ASSESSMENT REPORT

Section 75W Modification

Orica Southlands Remediation and Warehouse Development Project – Flood Storage Reconfiguration (MP 06_0191 MOD 1)

Figure 4: Proposed Modification to Site Layout

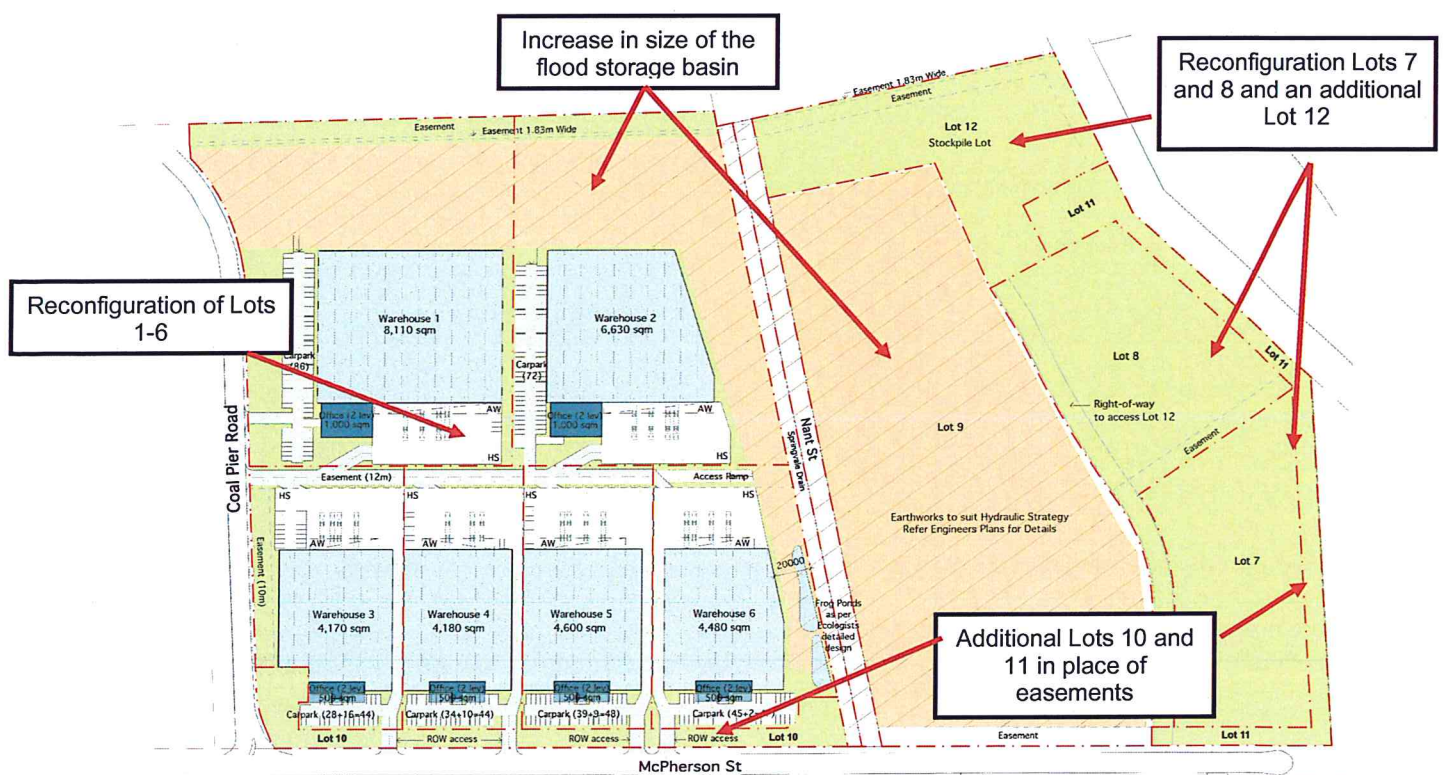
The key changes sought by Orica are illustrated in **Figures 4** and **5** and summarised below:

- reconfiguration of the approved compensatory flood storage basin;
- reduction in the warehouse gross floor area from 46,500m² to 36,170m²;
- slight reconfiguration of internal traffic circulation to allow trucks to move through the site in a one way direction;

- a weir comprising a natural channel constriction in Springvale drain (the original approval did not define the type of weir);
- a revised subdivision and easement plan which proposes:

- minor reconfiguration and reduction in size of lots 1-6;
 - reconfiguration of approved Lots 7, 8 and 9 to create three development Lots (7, 8 and 12) over the eastern, unexcavated portion of the site, and Lot 9 (the compensatory flood storage basin on the eastern half of the site);

- two additional Lots (10 and 11), in place of the originally proposed easements for the Botany Groundwater Clean Up Project (BGCuP); and
- relocation of the frog ponds.

To cater for the reduced flood storage area along the sites eastern boundary, the Proponent now seeks to extend the compensatory flood storage basin further to the north and to west.

The modified design is based on recent investigations and advice from the Proponent's hydrogeologist. The new information has meant that the basin has to be reconfigured, making it shallower and expanding to the western side of the site and further to the north (see **Figure 4**).

Figure 6 Modified Development Scenario 1% AEP flood level difference from Pre-Approval levels

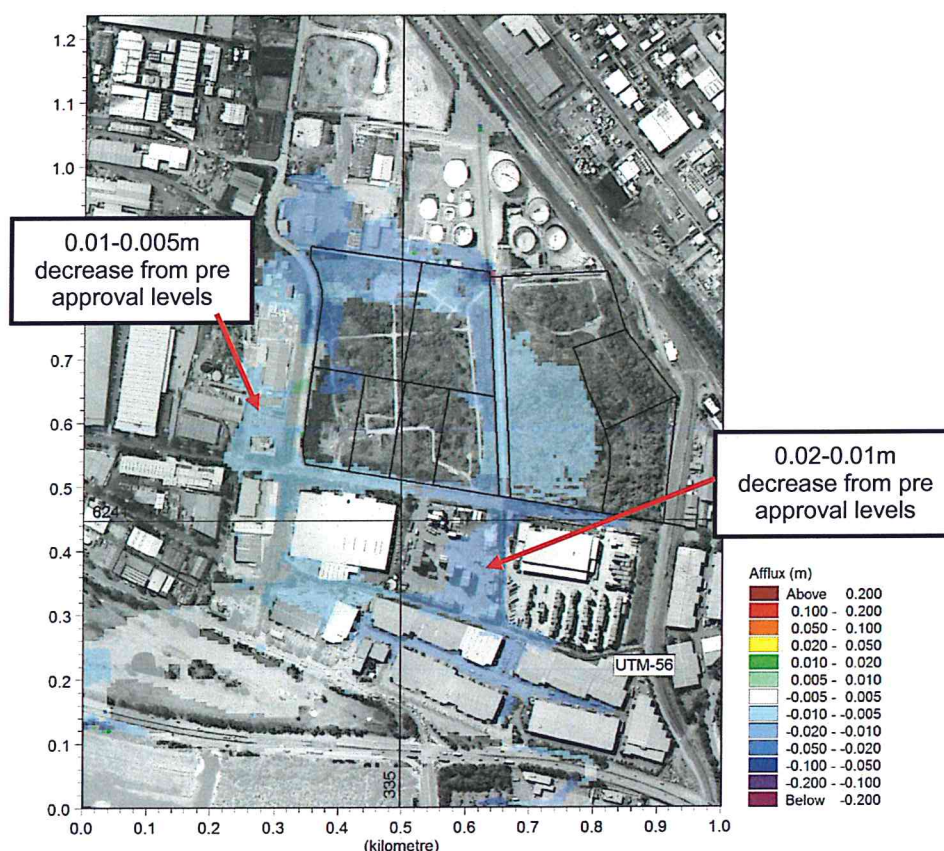
The results of Aurecon's modelling indicate that the revised flood detention basin would still reduce existing peak flood levels on adjoining properties (see **Figure 6**).

Concerns were raised by a public submission over the modelled increase in flood impacts over the original Aurecon modelling (done as part of the Project Application). However according to the Department's expert, the change in flood levels is still satisfactory as the modification would still achieve a reduction in existing flood levels (as shown in **Figure 6**).

Figure 7: Modified Development 1% AEP flood level change from approved.

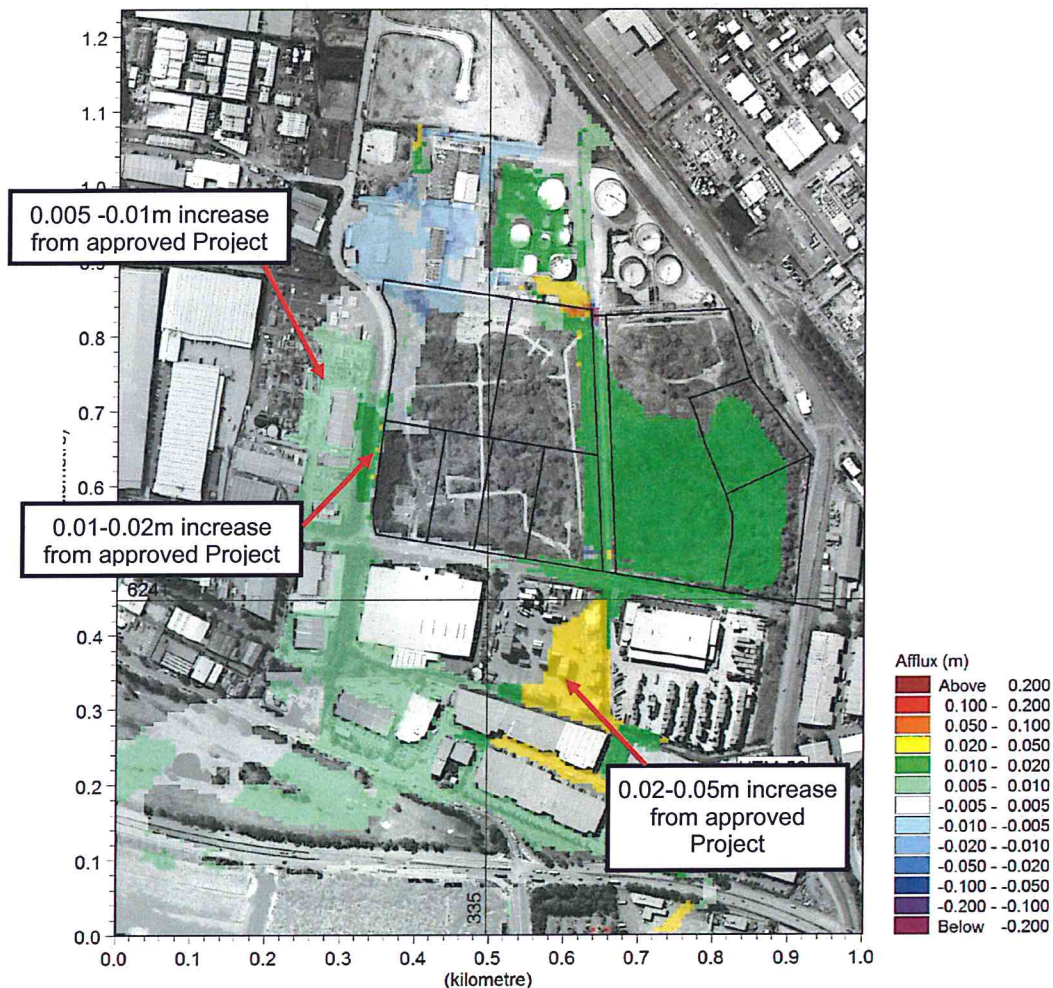
However, the proposed modification would slightly increase the flood levels anticipated by the approved Project's design (see **Figure 7**). For example, the 2010 results indicated a 0.04 reduction in peak level at a certain location and the modified proposal results show only a 0.02 reduction at this location. This means that the peak levels have increased compared to the 2010 results but the design level is still below the existing or pre development level.
